Access Compliance Report

Public Rights-of-Way (Curb Ramps)

Intersection ID: 13598	Main Street: W_KINGSTON_AV	Cross Street: WICKFORD_PL	Location: NW
ADA ID: 9035F92F3A41	Ramp Type: Directional1	Initial Pass/Fail: Fail	Overall Compliance: No
		Severity Score: 1.25

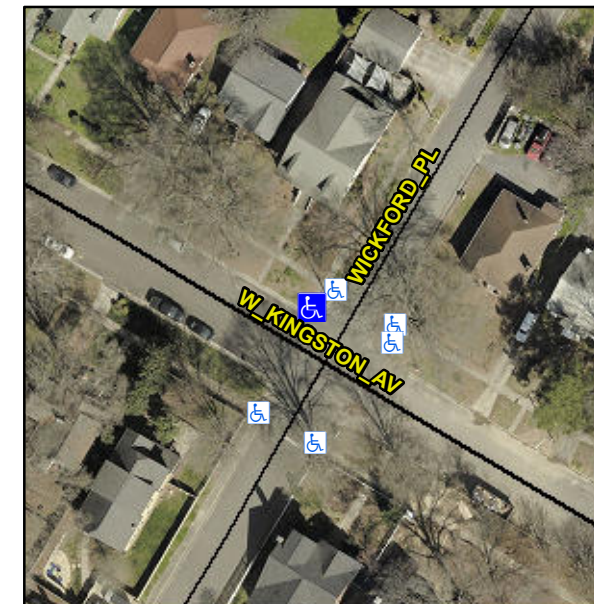
R304.5.3

Compliance	Description	Data	Compliance	Description	Data
N/A	Ramp Length (in)	126.0	N/A	Grade Break?	N/A
Yes	Ramp Width (in)	60.0	N/A	Grade Break Slope (%)	0.0
Yes	Ramp Slope (%)	6.6	N/A	Grade Break XSlope (%)	0.0
No	Ramp XSlope (%)	2.6			
N/A	Flare Type LT	N/A	N/A	Flare Type RT	N/A
N/A	Flare Slope LT (%)	N/A	N/A	Flare Slope RT (%)	0.0
N/A	Flare Traversable LT?	N/A	N/A	Flare Traversable RT?	N/A
N/A	Landing Length (in)	0.0	N/A	DWS Provided?	N/A
N/A	Landing Width (in)	0.0	N/A	DWS Contrast?	N/A
N/A	Landing Slope (%)	0.0	N/A	DWS Length (in)	N/A
N/A	Landing X Slope (%)	0.0	N/A	DWS Full Width?	N/A
N/A	Landing Curb? (Y/N)	N/A	N/A	DWS Offset LT (in)	N/A
N/A	Shared Landing?	N/A	N/A	DWS Offset RT (in)	N/A
N/A	Gutter Ponding?	0.0	N/A	Gutter Slope (%)	N/A
N/A	Gutter Lip Ht (in)	0.0	N/A	Gutter X Slope (%)	N/A
N/A	Painted X Walk1?	No		Road Slope (%)	3.6
	X Walk 1 Direction	To SW		Road X Slope (%)	3.0
	X Walk 1 Width (in)	N/A		Clear Space?	N/A

Remove & Replace Entire Ramp.
